# memo

Project Name | Brown's Creek Restoration project

Regarding | Regulatory Review Memo

Figure 1: Site Plan

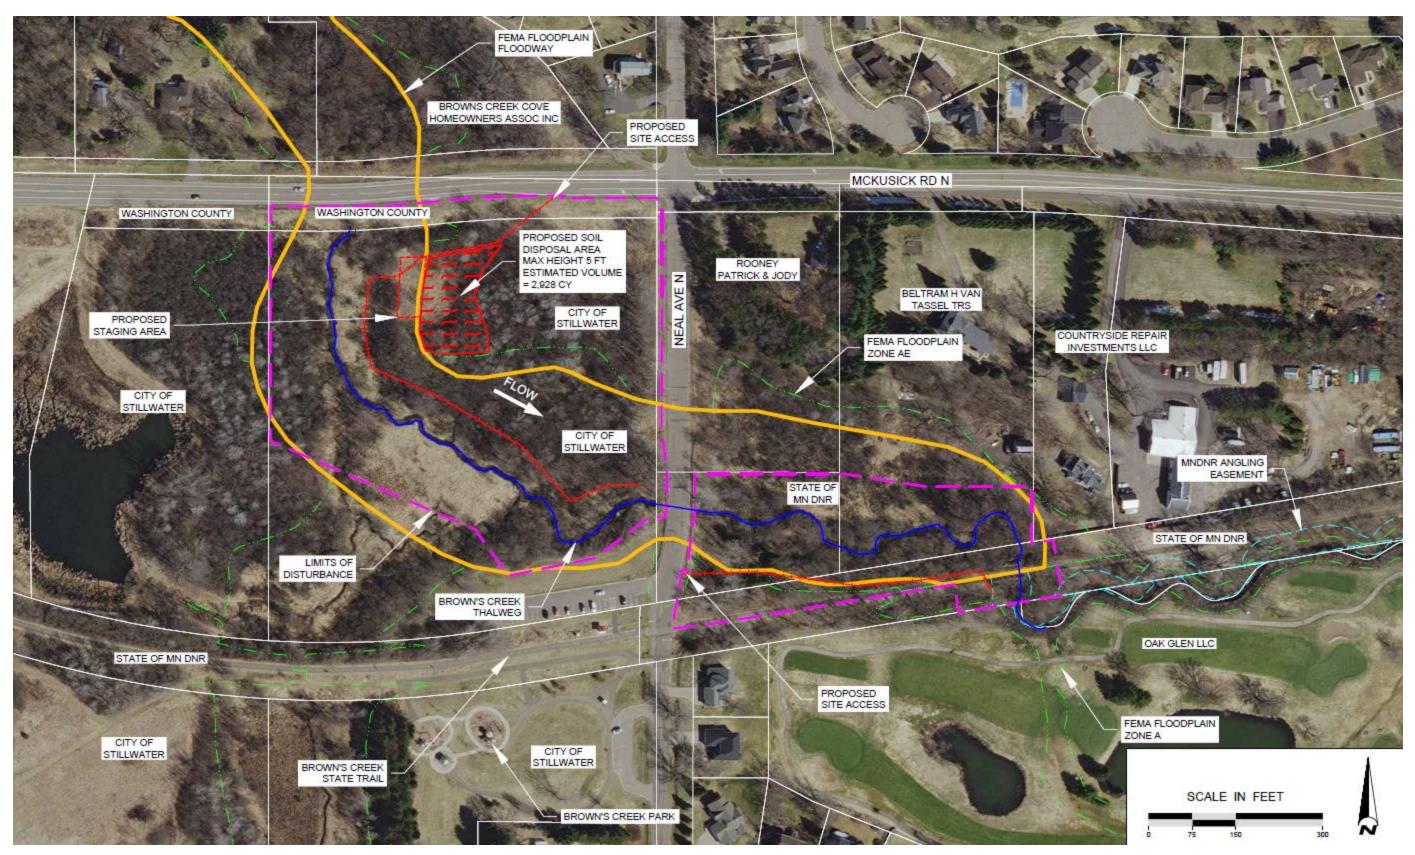
Recommendation: Proposed project plans are consistent with BCWD rule requirements

**Recommendation:** The BCWD engineer confirms that the proposed project conforms to applicable BCWD rule requirements.
